**This kit services 103-3097 mule drive belt
used on Serial Numbers 370,000 through 398,999 Exmark Lazer only.**

**Old Assembly # 103-1106 (52 & 60)
Old Assembly # 103-1082 (72)**

**New Assembly # 103-1081 (52 & 60)
New Assembly # 103-1083 (72)**

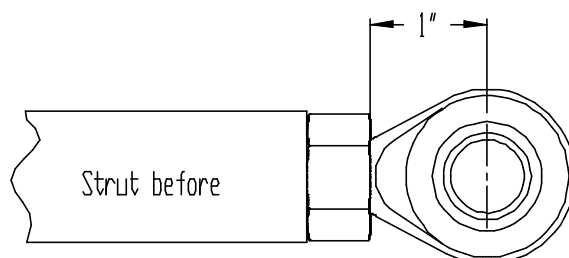
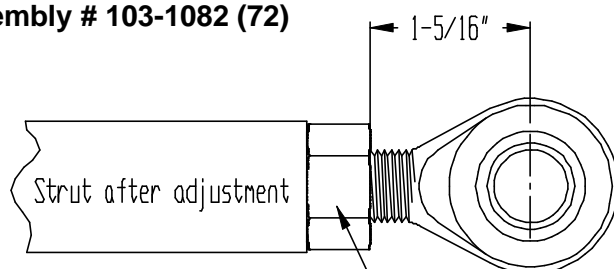
Before installing new mule drive belt:

- 1) Measure between the 5/8 lock nut at the rear of the deck strut and the center of the rear strut bolt / ball joint. If this measures 1-5/16" as shown, skip to step 7.
- 2) Remove both 5/8 x 5 rear deck strut bolts.
- 3) Loosen 5/8 lock nuts on struts.
- 4) Adjust ball joints (lengthen strut) 5-1/2 to 6 turns to 1-5/16" as shown, from lock nut to center of ball joint.
- 5) Re-assemble ball joints to frame with rear strut bolts. Tighten bolts securely.
- 6) Tighten 5/8 lock nuts against struts. Torque nuts to 120-150 FT-LBS.
- 7) Install new 103-4014 belt included in kit. Refer to your Operators Manual for proper mule drive belt tension adjustment.
- 8) Replace your old Parts Manual with the manual (p/n 103-3059) included in Kit.
